Wollongong Local Planning Panel Assessment Report – Electronic Meeting

WLPP No.	Addendum Report
DA No.	DA-2021/542
Proposal	Residential - minor demolition works and alterations to existing building and use of building as a multi dwelling development - three (3) dwellings
Property	195 Lawrence Hargrave Drive, THIRROUL NSW 2515
Applicant	JIH Building Design Pty Ltd
Responsible Team	Development Assessment & Certification – City Wide Planning Team (RT)

ADDENDUM REPORT

DRAWING: Site Plan
PROJECT: PROPOSED DEMOLITION OF UNAUTHORIZED WORKS & ALTERATIONS & ADDITIONS
SUBJECT: DEVELOPMENT APPLICATION

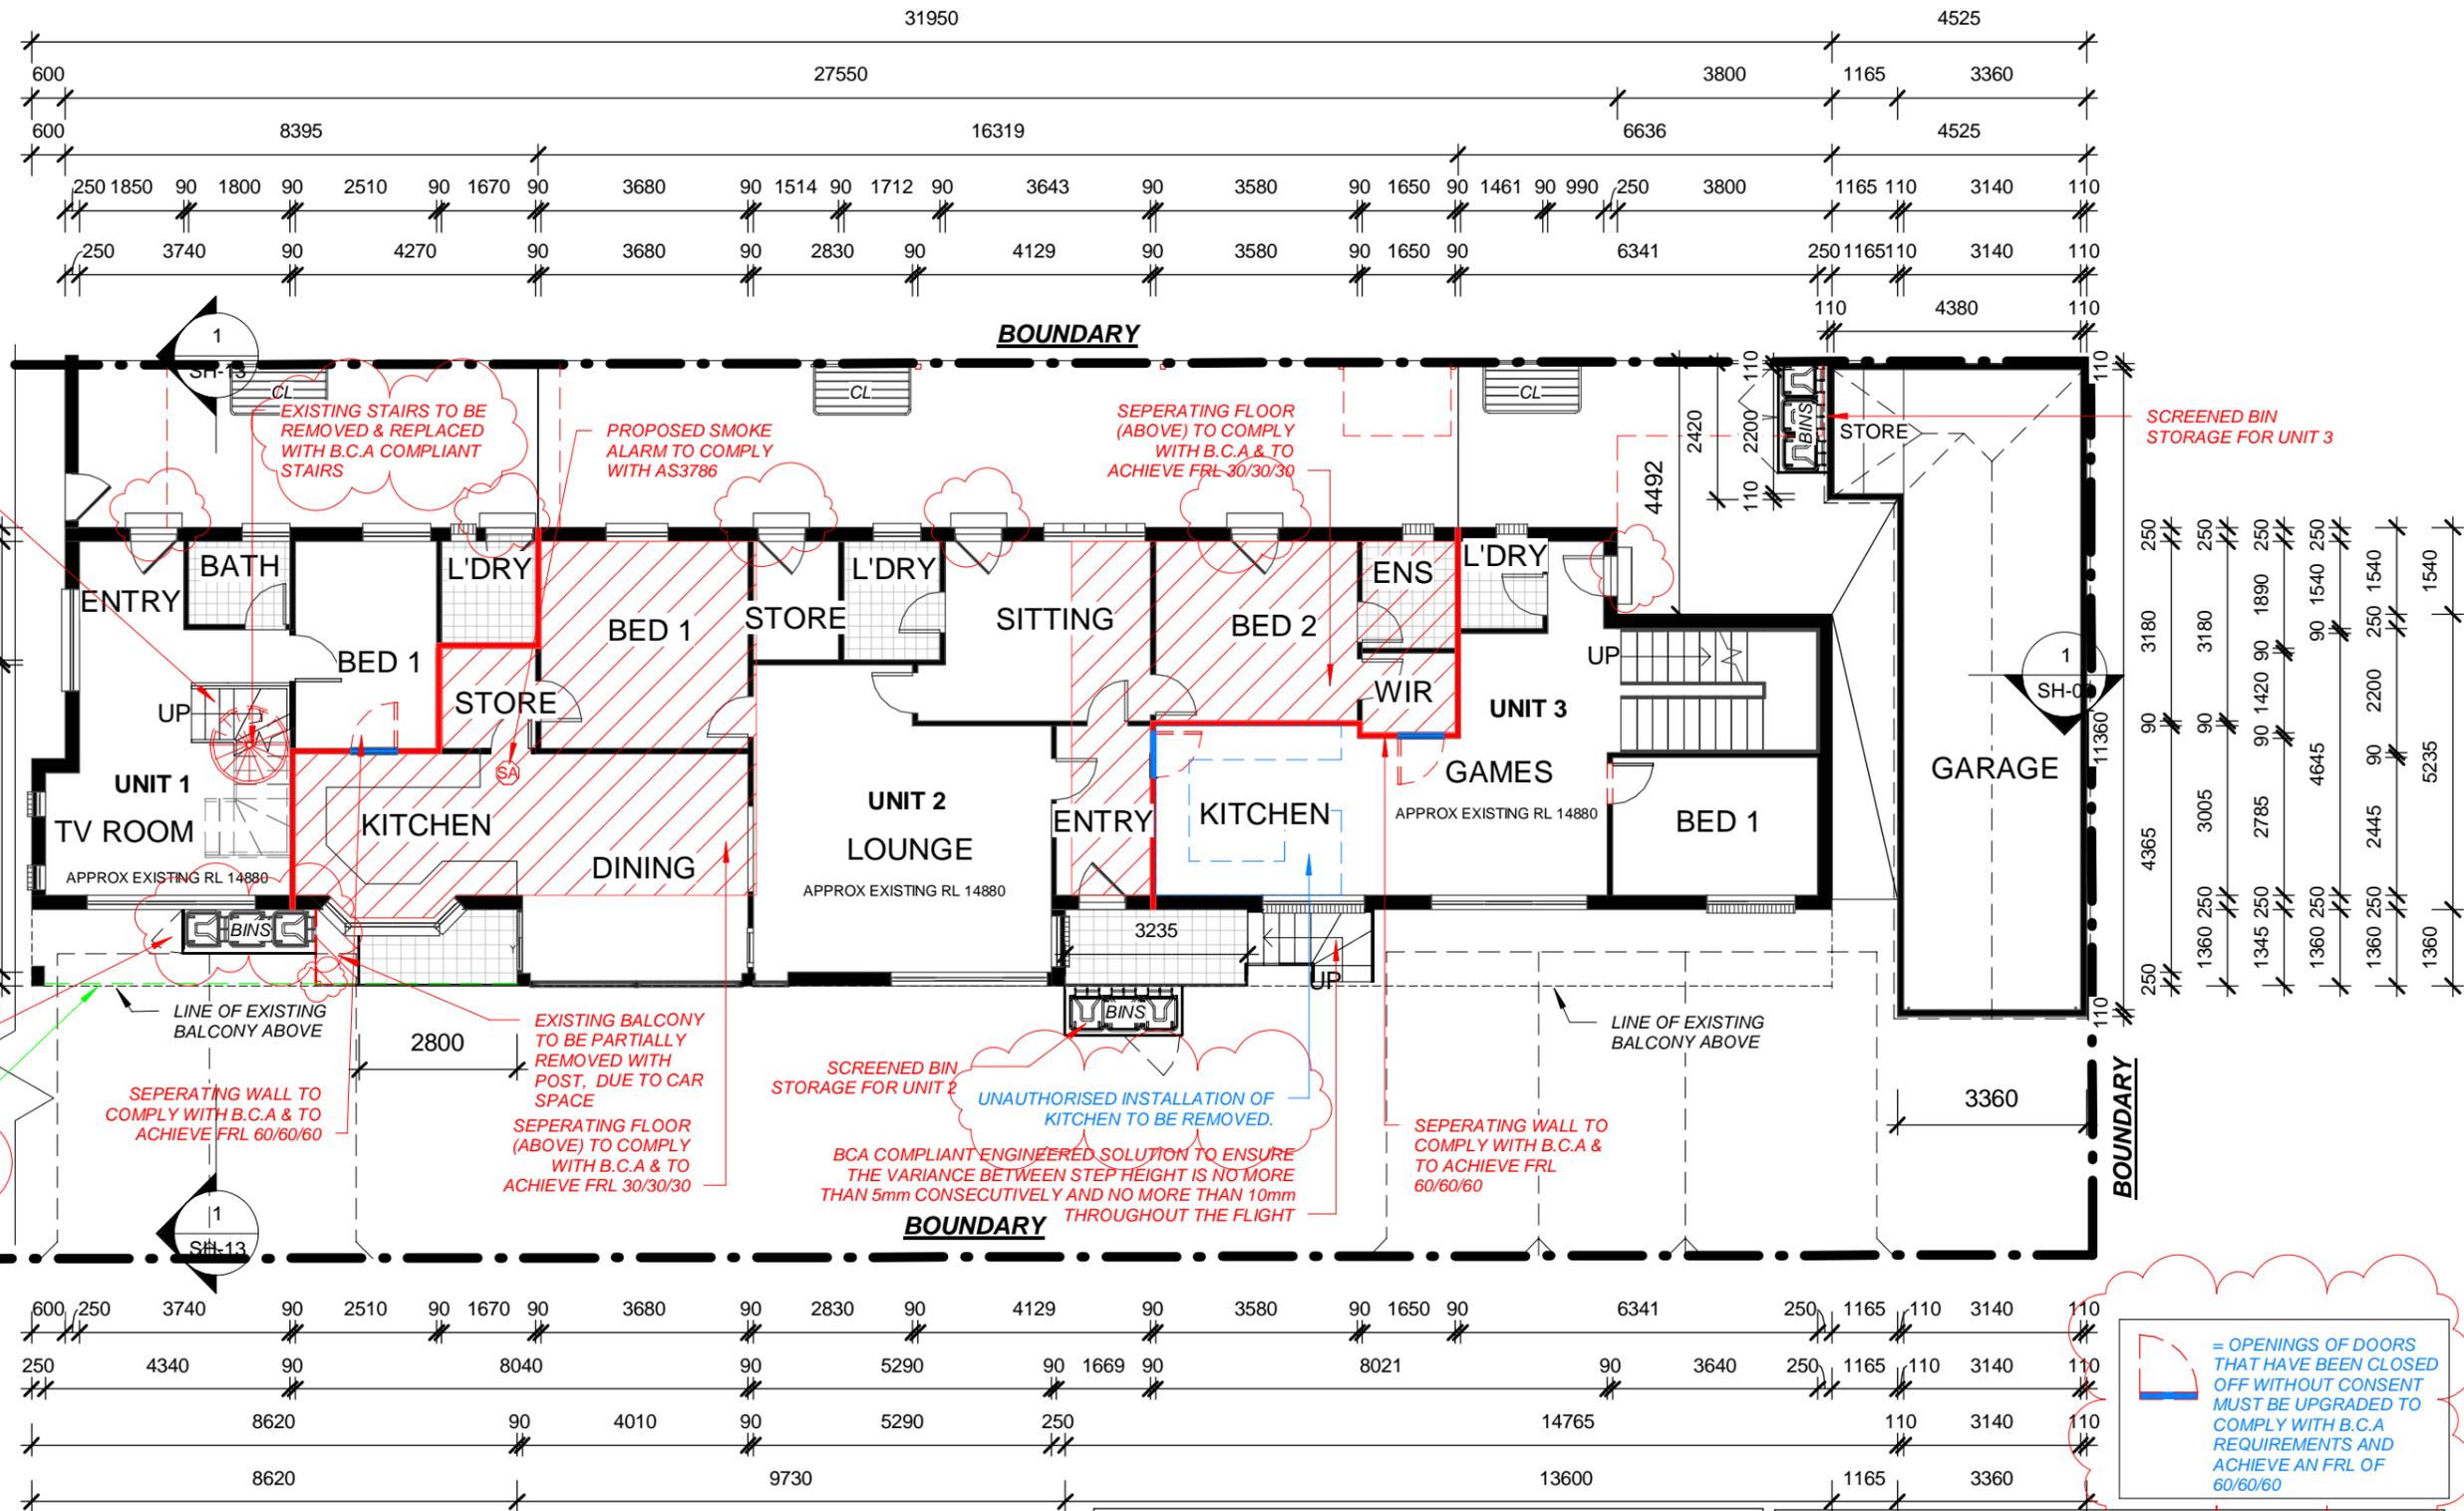
- “1. The plans lacked clarity, accuracy and consistency and the Panel requires the following to be documented on all the plans:
 - a. The frangipani tree to be retained.

- d. Coloured in blue, the elements of the building which have been constructed without consent.
 - e. The garbage storage to unit 1 to be relocated to the Jones Lane frontage and enclosed.

An amended Site Plan and Landscape Plan has been submitted as at **Attachment 2** detailing the retention of the frangipani tree.

The garbage storage for Unit 1 has been relocated to the Jones Lane frontage of Unit 1. The Site Plan, Ground Floor Plan and South west Elevation have been amended as at Attachment 2 to reflect the requested change.

DRAWING: Ground Floor Plan

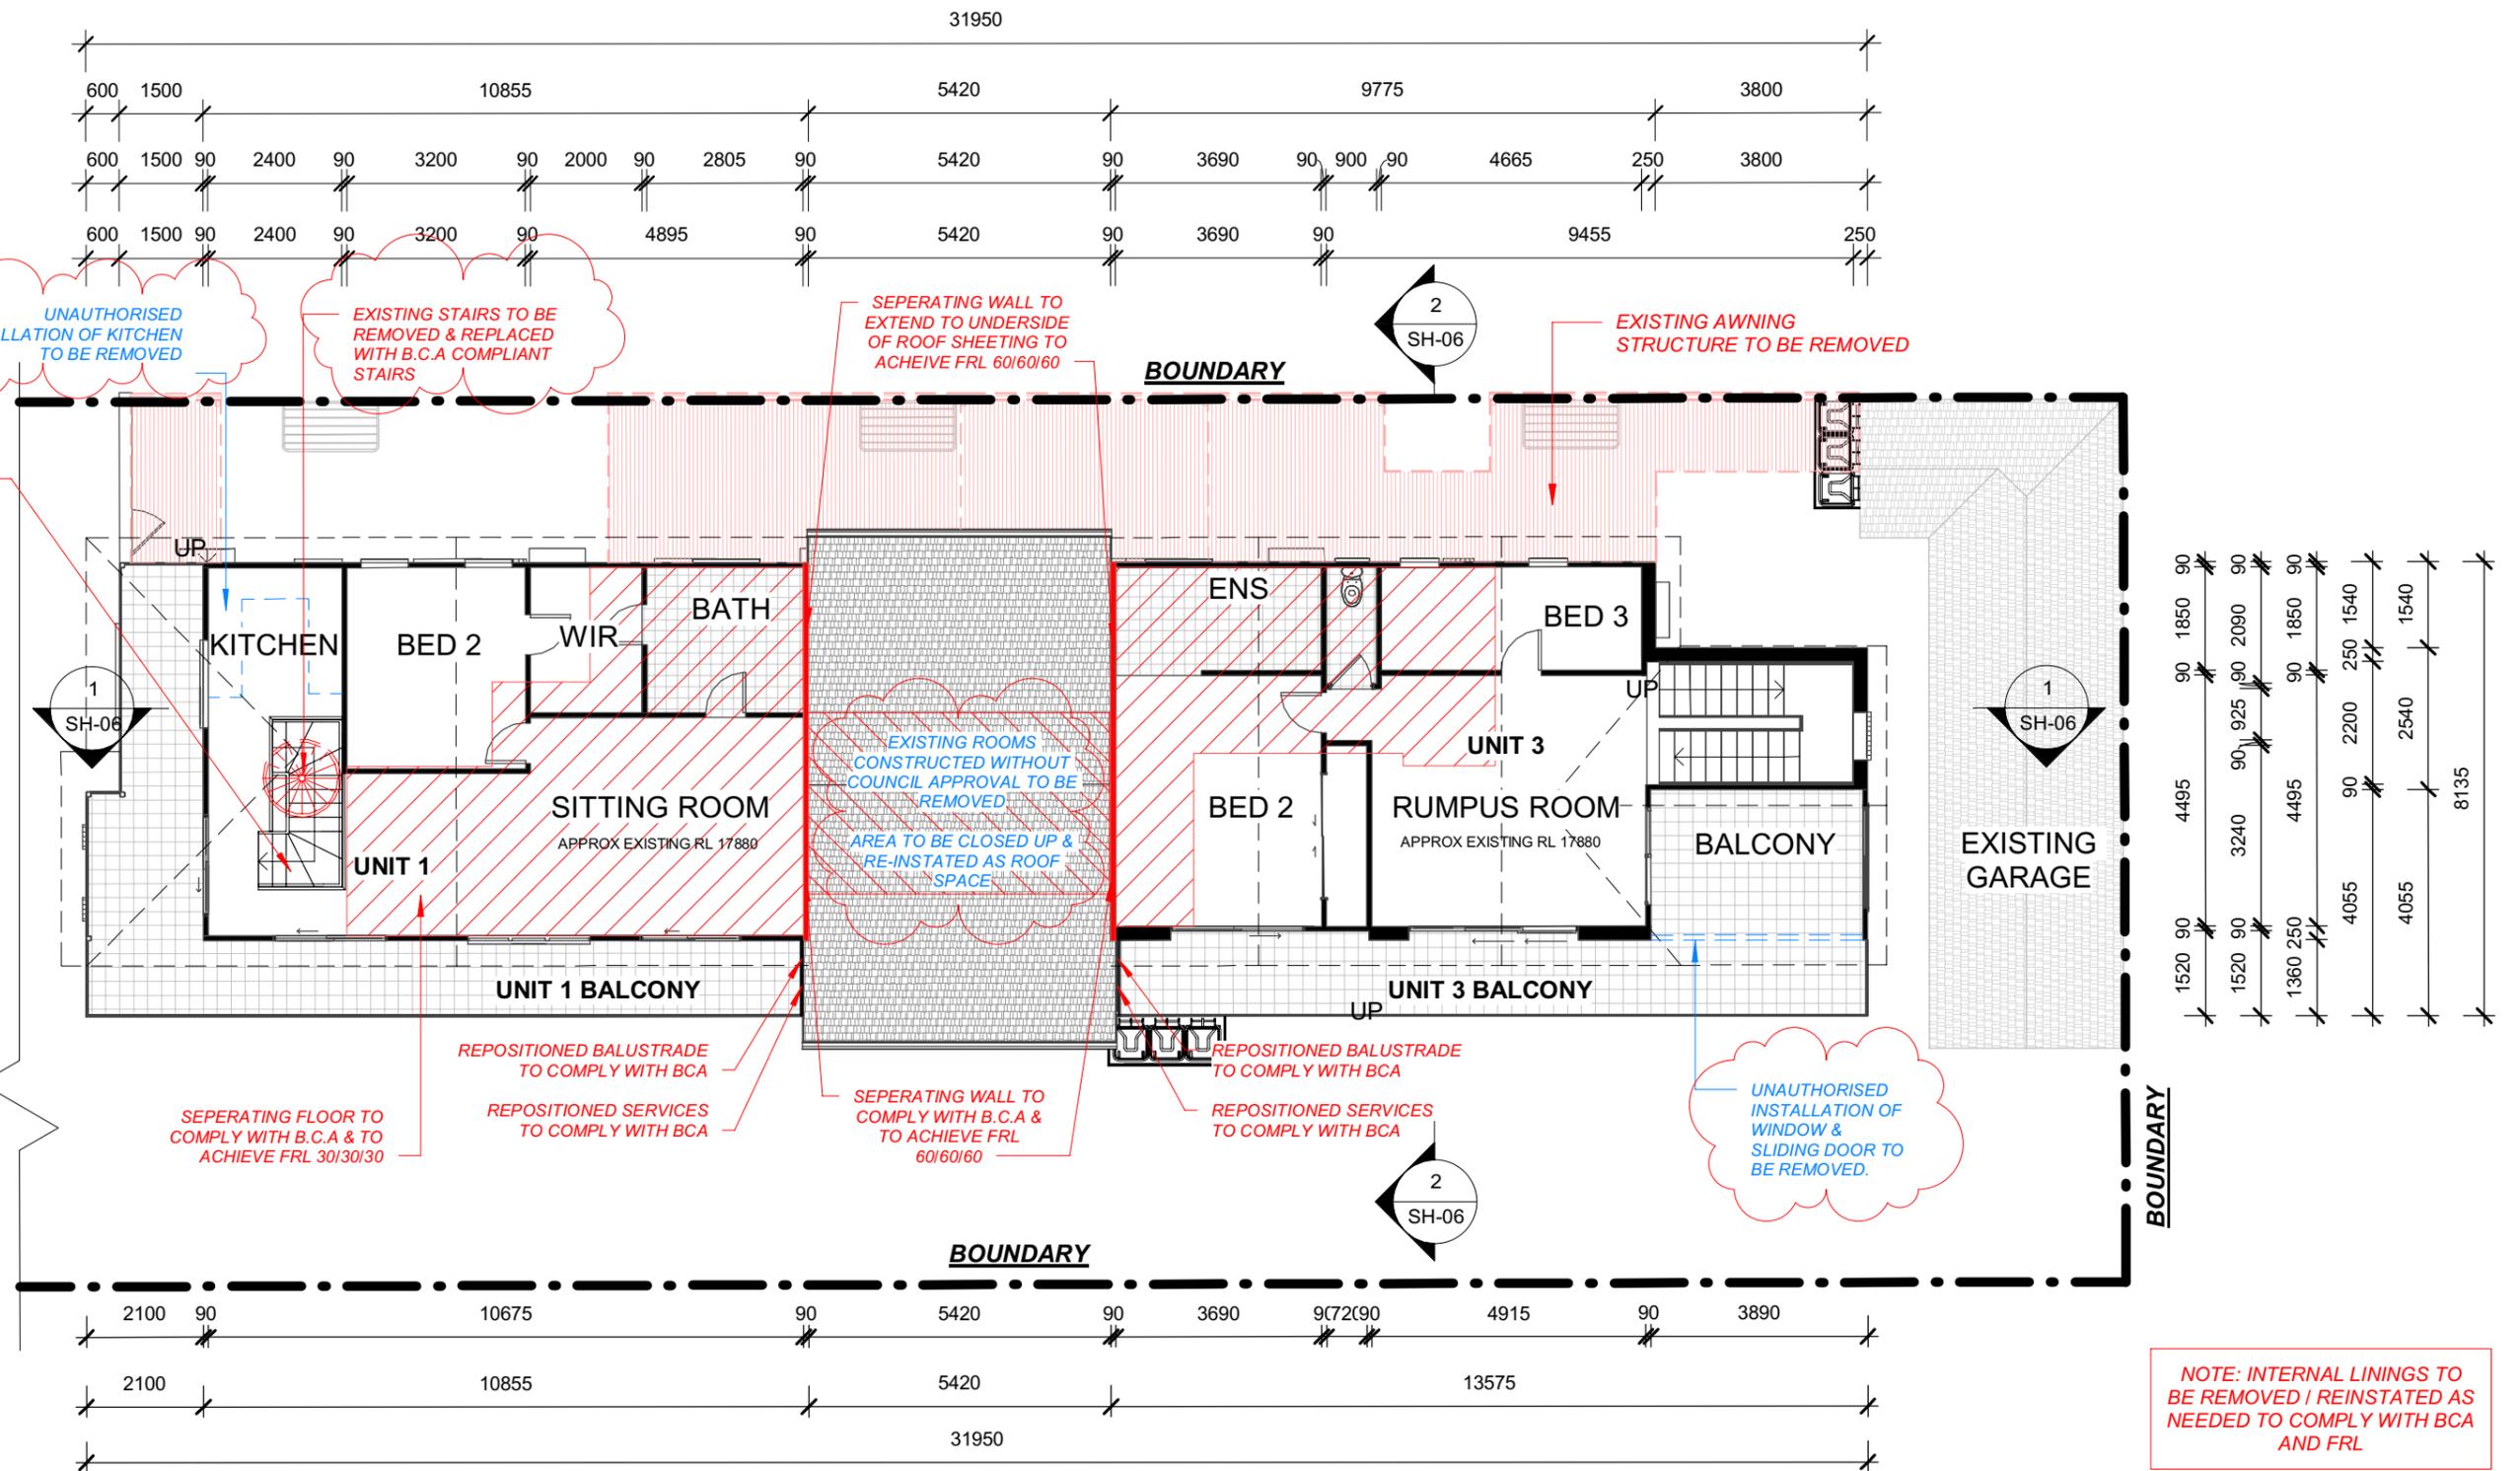
- b. The proposed new path and breach in the wall on the Lawrence Hargrave Drive frontage to be deleted from the landscape plan.
 - c. The steps from all units to the rear courtyards.

- f. The door to bedroom one of unit 3 to be relocated away from the stairwell.*
- b. A structural engineering report to be provided which establishes the feasibility of the proposed removal of the structural post from the existing ground floor balcony adjacent to the proposed kitchen to unit 2.*

An amended Ground Floor Plan has been submitted as at **Attachment 2** that now details the steps from all units to the courtyards.

The Ground Floor and First Floor Plans as at **Attachment 2** have been amended detailing unauthorised works in blue.

The Ground Floor Plan as at **Attachment 2** has been amended relocating the door to bedroom 1 of Unit 3 away from the stairwell.
